STAFF REPORT
(Final Plat; Preliminary Approved 9/24/87)

CASE NUMBER: S/D 87-91 - REFLECTION RIDGE COMMERCIAL

Re: Final Plat S/D 87-91 - REFLECTION RIDGE COMMERCIAL

sheet title: PRELIMINARY PLAT

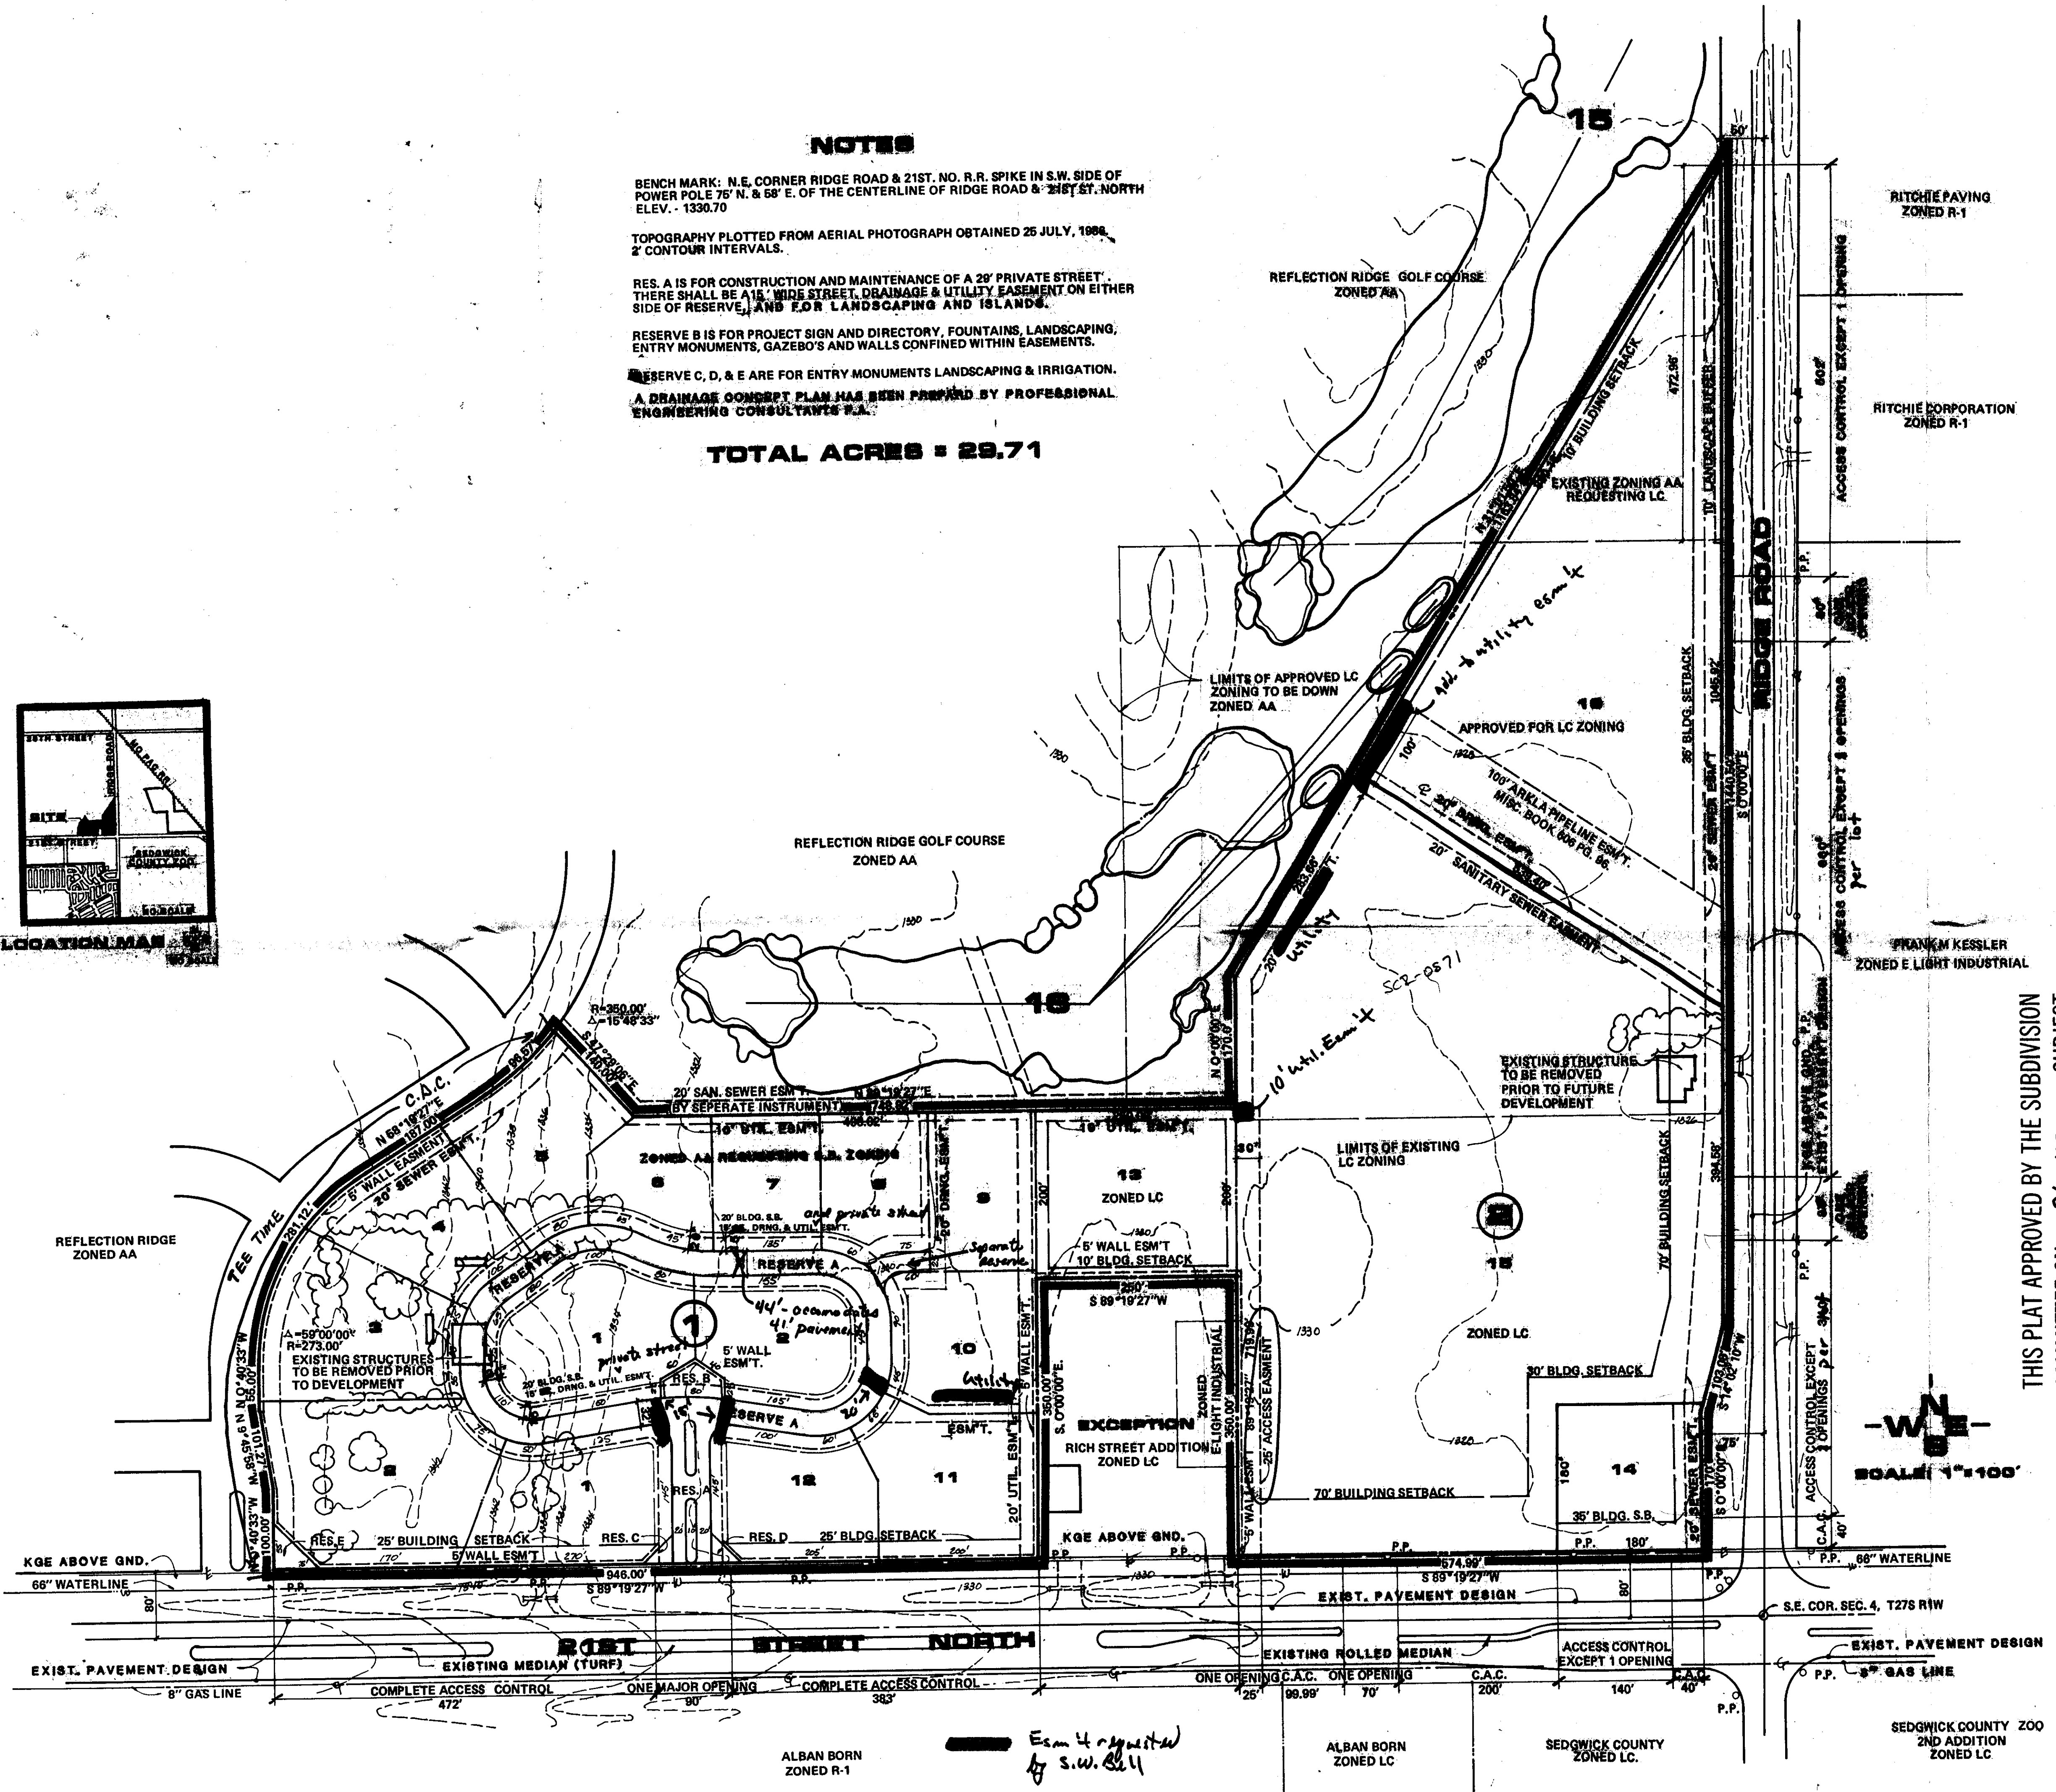
- N. Since building setbacks are being platted, the final plat tracing shall delete the note in the plat's text and on the face of the plat that states building setbacks are per the CUP.

- A. The applicant shall guarantee the extension of sanitary sewer to serve the lots being platted.
- B. The applicant shall guarantee the extension of City water to serve the lots being platted.

- C. The applicant shall guarantee construction of the storm sewers required by this plat.
- D. The applicant shall guarantee any drainage improvements required by the platting of this property.

- E. As required by general provisions #5 of the associated Community Unit Plan, the applicant shall guarantee the following roadway improvements for 21st Street North and Ridge Road:

1. The applicant shall guarantee the reconstruction of the medial in 21st Street North to provide for an eastbound left turn lane or a fifth lane providing for left turn storage to serve Lots 1 through 12, Block 2 and Block 1 (proposed office park).

2. The applicant shall guarantee the construction of a temporary third lane for Ridge Road adjacent to this plat. As agreed at the time of CUP approval, this guarantee shall be held until development occurs. Partial development may necessitate partial construction of the third lane.

3. The applicant shall guarantee the construction of a fifth lane in 21st Street North to serve the permitted opening to Lot 15, Block 2. Also, the applicant shall guarantee a third lane in Ridge Road to accommodate left turns into the major entrances required to serve Lot 15, Block 2 and Lot 16, Block 2.

4. The applicant shall guarantee the construction of a decel lane on 21st Street to serve this plat. This guarantee shall provide for construction of that part of the major entrance, required to serve the proposed office park (Lots 1 through 12, Block 2), that is within street right-of-way. The applicant shall guarantee the construction of a decel lane on Ridge Road to serve this plat. This guarantee shall provide for construction of those parts of the two required major entrances that are within street right-of-way.

- G. Provisions shall be made for ownership and maintenance of the proposed reserves. The applicant shall either form a lot owners' association prior to recording the plat or shall submit a covenant stating when the association will be formed, when the reserves will be deeded to the association and who is to own and maintain the reserves prior to the association taking over those responsibilities. The covenant shall also specify that hard-surfaced access will be provided to any lot prior to development of that lot.

- H. The final plat shall state in the plat's text the purposes of the proposed reserves as well as who is to own and maintain the reserves.
- I. On the final plat tracing, the reference in the plat's text to Reserve A shall be amended to state that the reserve is platted for a private drive and not a street. Also, no reference to a street should be used on the 15-foot drainage and utility easement paralleling the private drive reserve. As was stated when the preliminary plat was approved with the "street to drive change", all lots within the office park will be assigned a 21st Street address and the private drive will not be given a separate street name.

- J. The applicant shall submit a copy of the instrument which establishes the Arkla Pipeline easement on this property. The applicant's agent should determine any setback requirements from the pipeline by researching the text of the pipeline agreement.

- K. The applicant shall provide proof, by letter from the pipeline company or by providing a copy of the pipeline easement agreement, that utilities and buildings may be located adjacent to the easement without restriction of an established setback from the easement.

- L. Any relocation, lowering or encasement of the pipeline, made necessary by this development, will not be at the expense of the City.
- M. The proposed joint access easement, on Lot 15, Block 2, will need to be established by separate instrument with appropriate recording information indicated on the final plat tracing. Prior to recording the joint access easement, a draft shall be submitted to the Planning Department for review
